DEVIATION REQUEST AND DECISION FORM

Project Name :	Grandview Reserve
Schedule No.(s) :	
Legal Description :	<p>A TRACT OF LAND BEING PORTIONS OF THE SOUTH HALF OF SECTION 21, SOUTH HALF OF SECTION 22, NORTH HALF OF SECTION 28 AND SECTION 27, TOWNSHIP 12 SOUTH, RANGE 64 WEST OF THE SIXTH PRINCIPAL MERIDIAN, EL PASO COUNTY, COLORADO, BEING DESCRIBED AS FOLLOWS:</p> <p>BASIS OF BEARINGS: THE EAST LINE OF SECTION 21, BEING MONUMENTED AT THE SOUTHEAST CORNER BY A 3-1/4" ALUMINUM SURVEYOR'S CAP STAMPED "PS INC PLS 30087 1996", BEING APPROPRIATELY MARKED, AND BEING MONUMENTED AT THE NORTHEAST CORNER BY A 3-1/4" ALUMINUM SURVEYOR'S CAP STAMPED "PS INC PLS 30087 1996", BEING APPROPRIATELY MARKED, BEING ASSUMED TO BEAR NORTH 00 DEGREES 52 MINUTES 26 SECONDS WEST, A DISTANCE OF 5290.17 FEET.</p> <p>COMMENCING AT THE SOUTHEAST CORNER OF SAID SECTION 21; THENCE NORTH 00 DEGREES 52 MINUTES 26 SECONDS WEST ON THE EAST LINE OF SAID SECTION, A DISTANCE OF 2645.09 FEET TO THE NORTHEAST CORNER OF THE SOUTHEAST QUARTER OF SAID SECTION 21, SAID POINT BEING THE POINT OF BEGINNING; THENCE NORTH 89 DEGREES 41 MINUTES 03 SECONDS EAST ON THE NORTH LINE OF THE SOUTH HALF OF SAID SECTION 22, A DISTANCE OF 39

Figure 1- Proposed Cross Section for MST

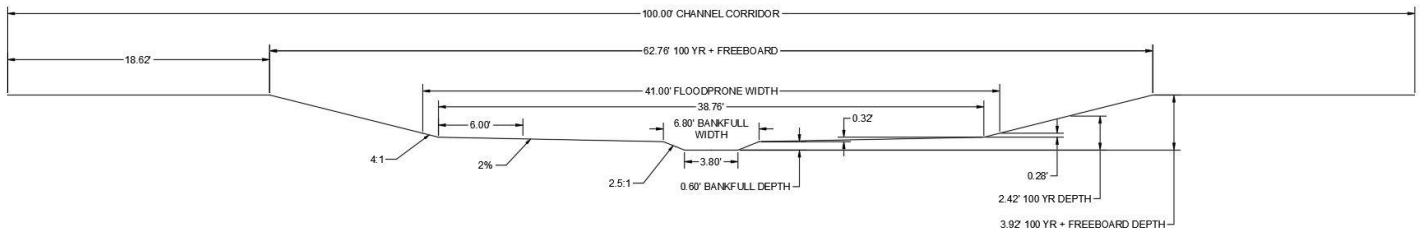
It is proposed to shift the existing channel away from its current alignment to facility the proposed land plan. The channel shift would allow for a 100-foot corridor to be dedicated to the channel and maintenance access. Initial modeling and calculations indicate the channel width at the 100-year water surface elevation + freeboard will need to be 62.76' wide. The additional ~40' width to the overall corridor will allow for maintenance access and for significant room to allow for flexibility in the naturalized channel design approach. Within the 62.76' valley the low flow channel is to meander in a fashion similar to what would be expected in an unaltered, stable reach based on the geomorphology of the project site.

Section 10.5.3 Bottom Width: It is requested that a bottom width of 3.8 feet and a bankfull width of 6.8 feet be permitted to facilitate a design that accounts for the wide range of expected flows through the stretch of channel being designed. This design variance is based upon guidance given in MHFD’s DCM volume 1 table 8-2. Based on a design flow depth of ~ 0.5 feet, it is recommended a minimum bankfull channel width of 6 feet be targeted. Through an iterative analysis it was determine that a cross sectional geometry with a bottom with of 3.8 ft, bankfull width of 6.8 feet would result in a flow depth of 0.6 feet for 70% of the 2-year event.
